# VALLEY CAMP OF UTAH, INC.

Re: Notice of Violation No. N85-2-3-2

DRAWN BY: <b>Ed Sanderson</b>	DATE: <b>MARCH 20, 85</b>
CHECKED BY:	DATE:
REVISED BY:	SCALE: <b>1" = 100'</b>
APPROVAL ENG.:	
APPROVAL SAFETY:	TITLE: <b>TRUCK SCALE LOCATION &amp; APPROACH - UTAH NO. 2</b>
APPROVAL MINE:

DRAWING NO. <b>A4-0056</b>	REV. NO. <b>1</b>
-------------------------------	----------------------

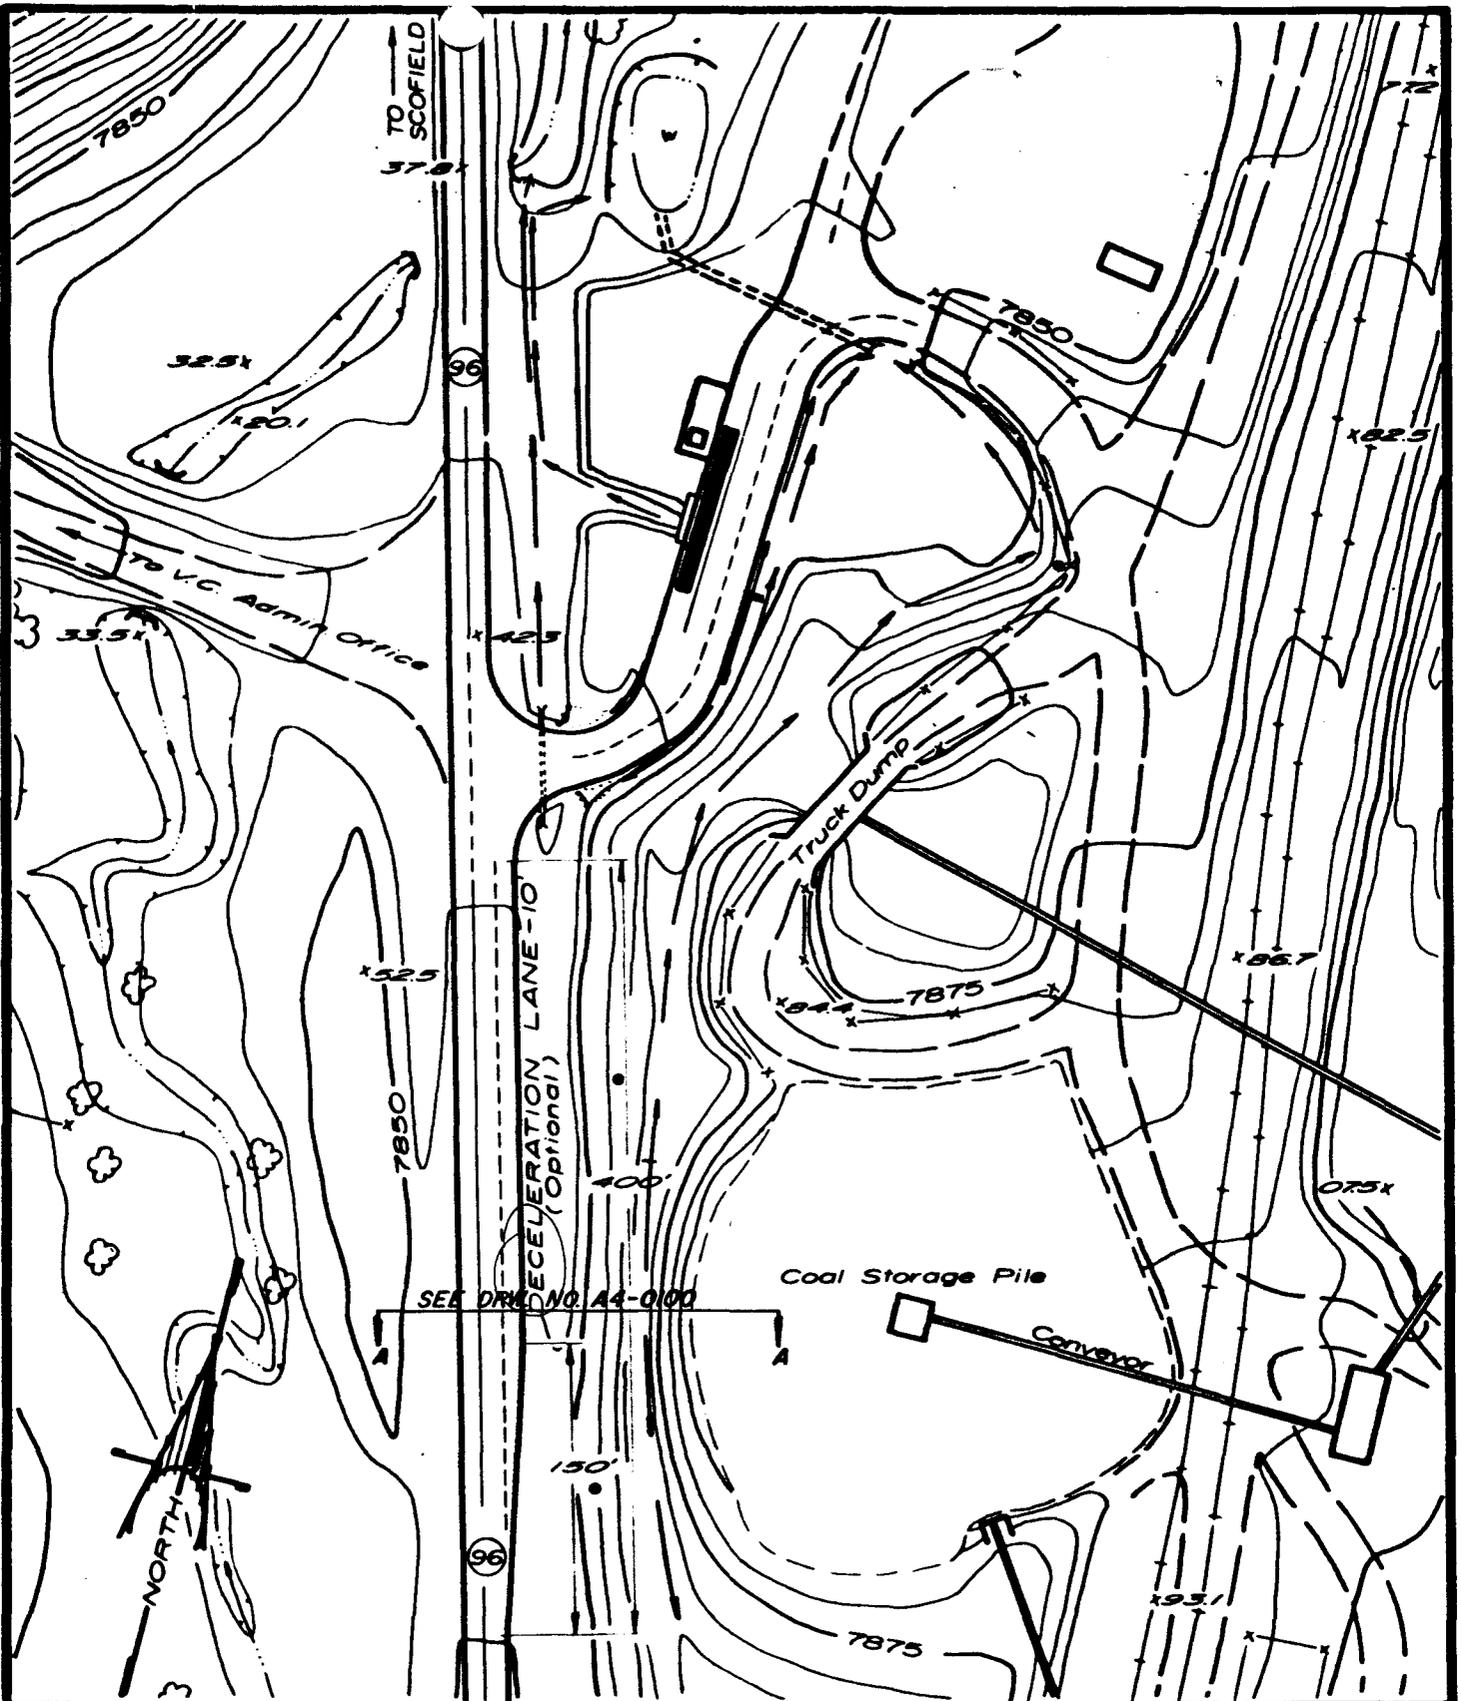
Concerning Part "B" of the required action, the drainage design around the east side of the truck scale access road has been changed. Approximately 170 feet up the ditch from the south gabion, we have installed a berm on block in the ditch. From this point, drainage will flow both directions. The flow to the north will terminate in the No. 2 sediment pond and the flow to the south will still be passed through the gabion filter. Both gabion filters have been cleaned out, and new straw placed in them. The location of the new beam and the change in the flow pattern is shown on the enclosed, revised Drawing No. A4-0056.
